Architectural Review Committee Staff Report Meeting Date: April 22, 2024

PETITION: Enclave at Deer Crossing Product Approval

REQUEST: Petitioner requests approval of the Elmstead E – Modern Prairie for Lot 12 of the

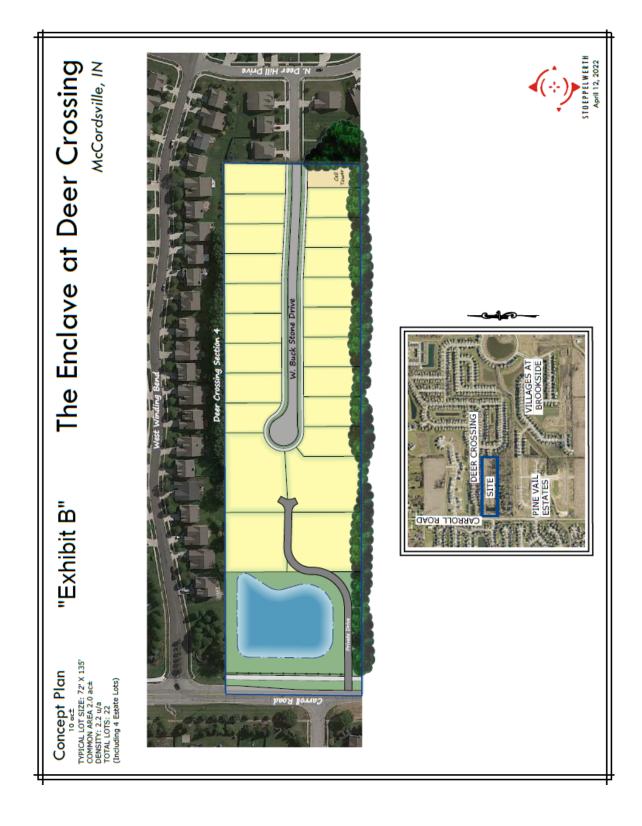
The Elmstead E – Modern Prairie, as presented, is almost entirely comprised of a brick and stone exterior. Staff finds the home, generally, in compliance with the architectural standards of the PUD, with the following exceptions:

- 1. Staff was unable to determine overhang depth based upon the plans provided; and
- 2. Staff is seeking confirmation that the shingles are dimensional.

Following resolution of the two items noted above, and review of anti-monotony, staff will recommend approval of this petition.
